APERTURE ON FIFTH

500 JOHN STREET, SEATTLE

DESIGN REVIEW RECOMMENDATION MEETING

DPD #3012936

DETAIL VIEW AT SIGHT TRIANGLE

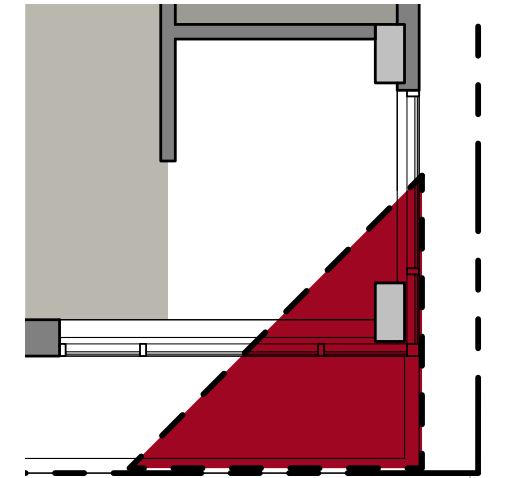
EDG Comment: Conflict between pedestrians on John Street with cars leaving the alley needs to be addressed. Design of the structure at the alley needs to provide high visibility when exiting the garage and alley. A “sight triangle” function should be provided by eroding the building or providing transparency, mirrors are not appropriate.

Response: The discharge point of the alley to John Street has been designed to include sight triangles intended to provide visual connection between pedestrians and vehicular drivers at the point of conflict. The proposed sight triangle is provided via transparency (windows) at the project corner of the building where it meets grade. The transparency will occur on both the alley and sidewalk facing facades and shall provide the required visual connection between the two conflicting elements; interior furnishings, signage or any other obstructions that could potentially screen the required transparency of the sight triangle are to be prohibited.

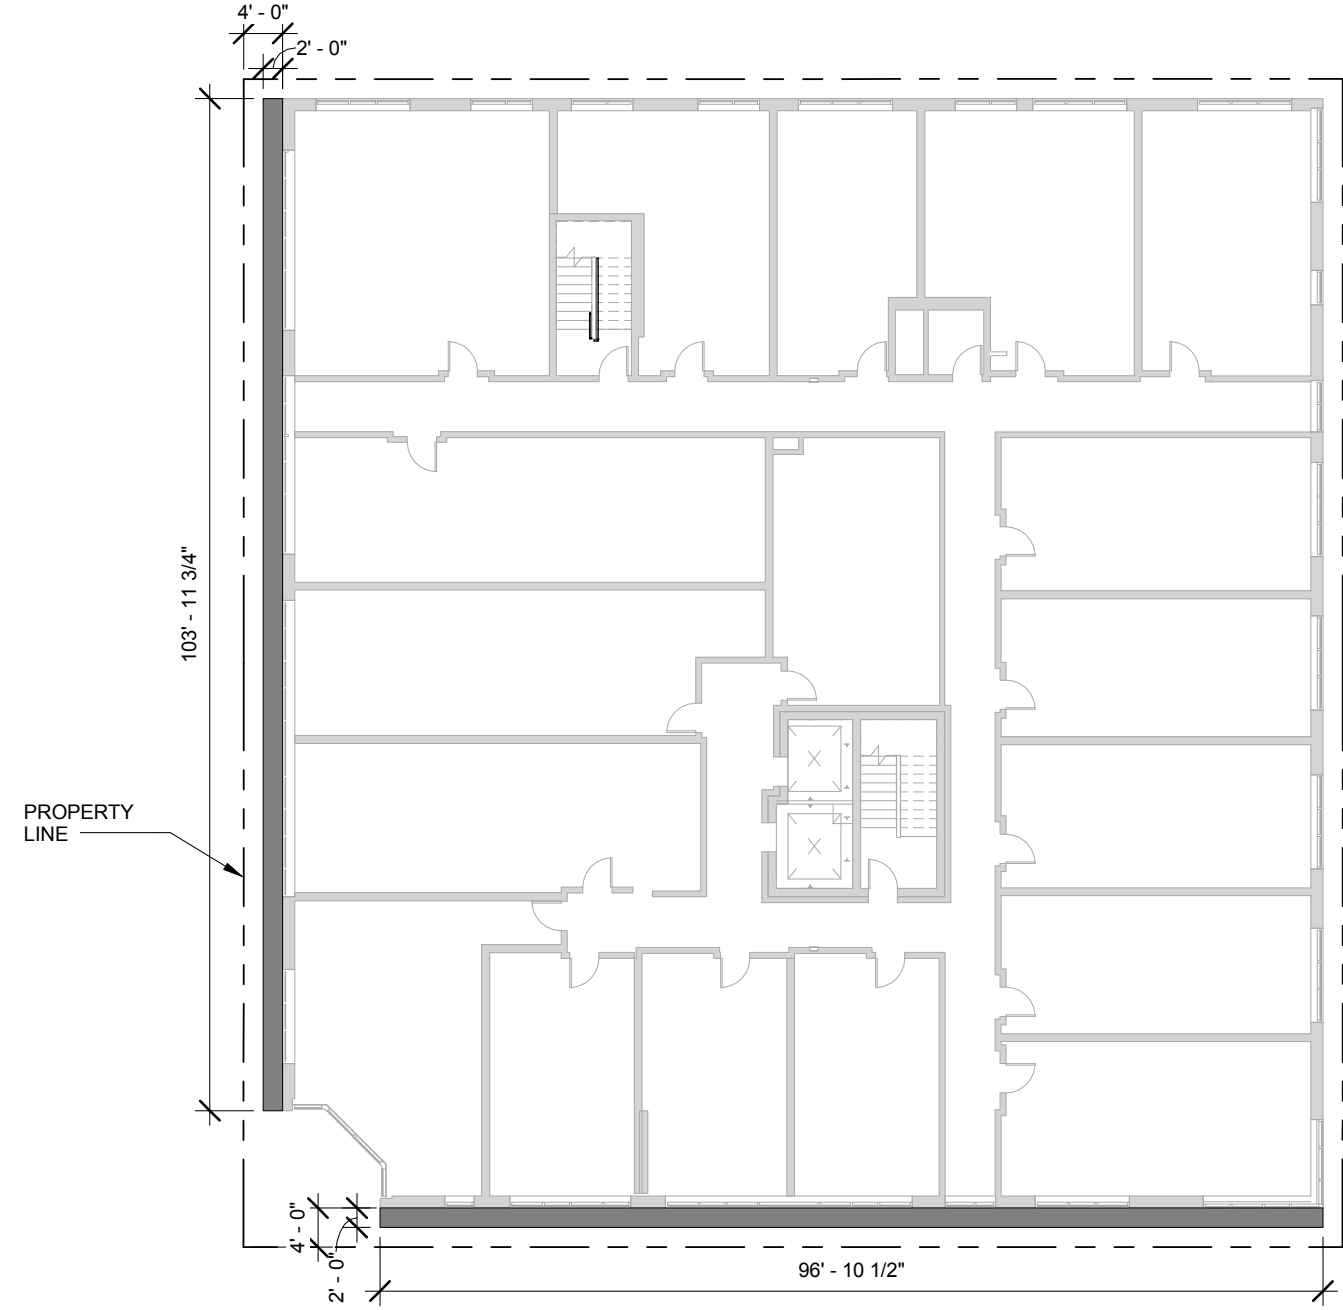
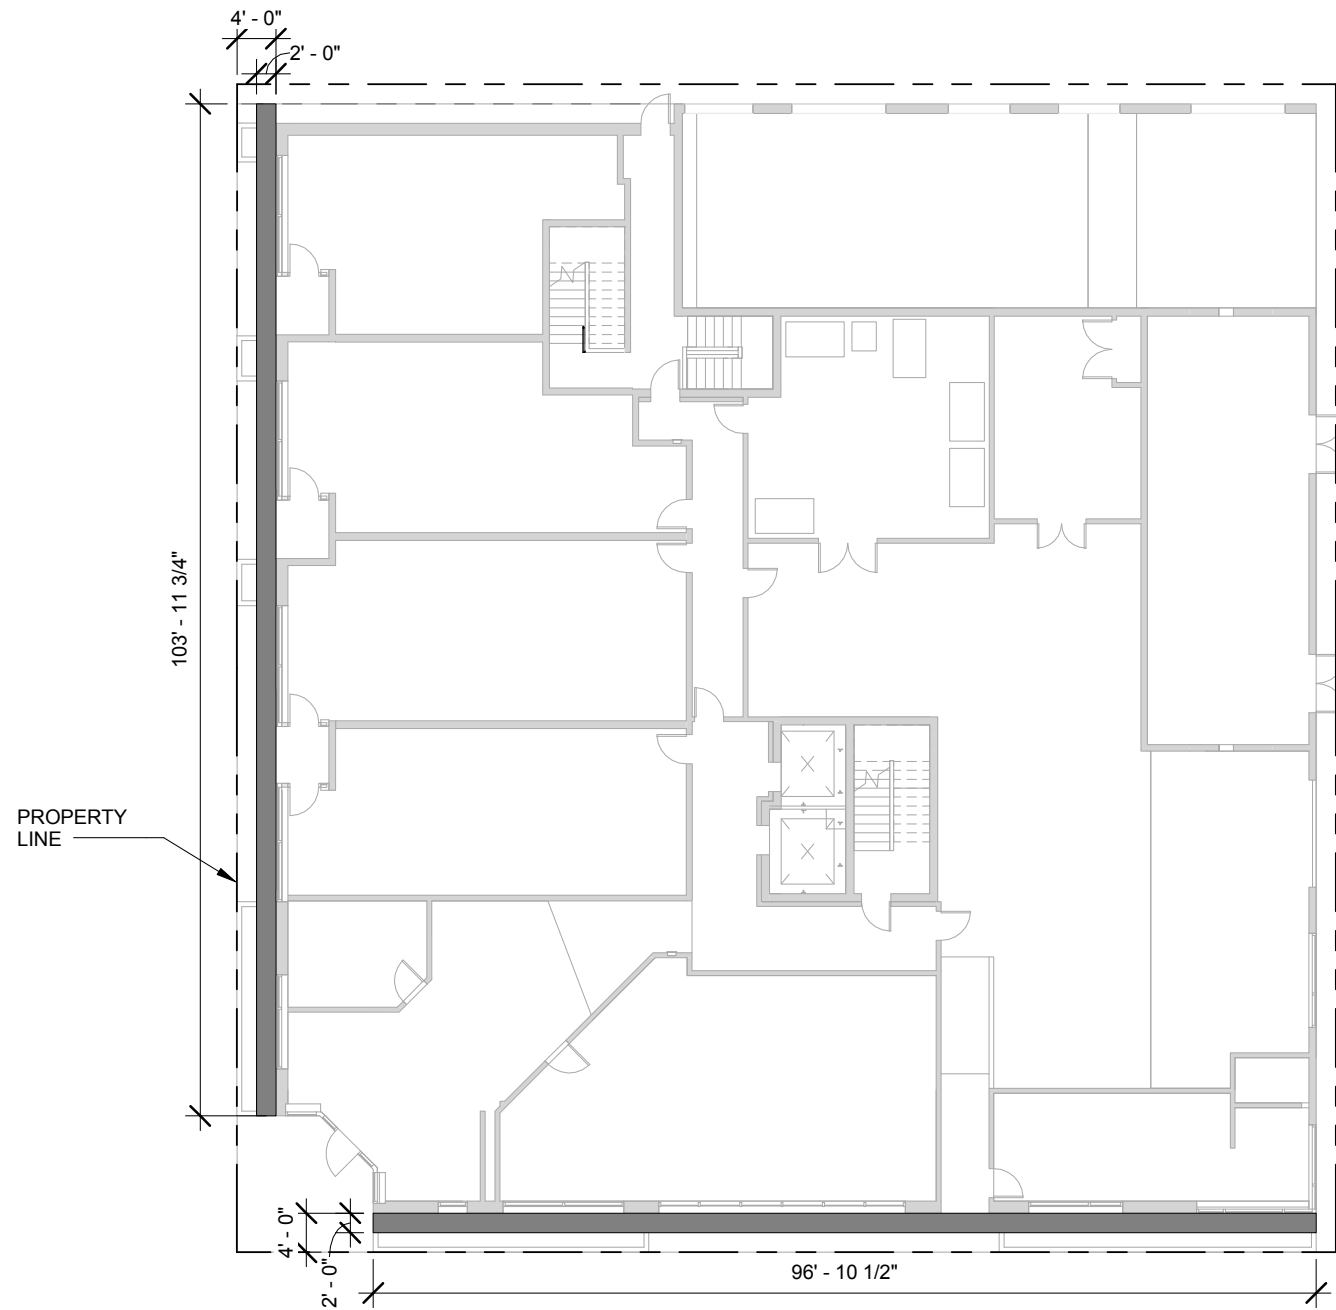
#2 Allowance of structural projections of bay windows into the right of way at specified locations. This provides greater flexibility in façade articulation to reduce the tendency of blocky, “bread loaf” facades. The departure request is for continuous bays exceeding the 9’-0” maximum width requirement, and to allow 90 degree corners perpendicular from the corresponding property line. The bay projections would match the overall width of selected units at the far corners of the building to create a more unified appearance, rather than a series of regimented closely spaced bays that would result in a potentially visually-noisy massing. The bays at each corner would be linked by a continuous belt course at the third floor, and a cornice at the roof line. Providing 90 degree terminations keeps with the surrounding architectural modern context, as opposed to the 45 degree bays that are more Victorian in nature. We are currently projecting 18” into the right of way at these locations. The glass enclosed projecting corridor spaces are currently within the structural overhang allowance, although the requested departure includes the allowance of these corridor to extend into the right-of-way. The projecting corridors create a bay window condition at the end of each corridor for enhanced views, additional natural light and enhances the appearance of the building.

The combination of the projecting bays with the recessed street-facing facades on the first and second floors will provide an added degree of pedestrian protection and will distinguish the base of the building from the upper floors on all 3 facades facing a right of way (5th Avenue N, John Street and the alley). At the EDG meeting, the Design Board recommended increasing the recessed façade at the first and second floors to provide additional space for the pedestrian, and allow more room to foster greater residential character. In response, we have increased these setbacks to 4 feet in lieu of the 2 feet proposed during the EDG. This departures will help maintain the square footage of the overall building that was lost by increasing the ground level setbacks.
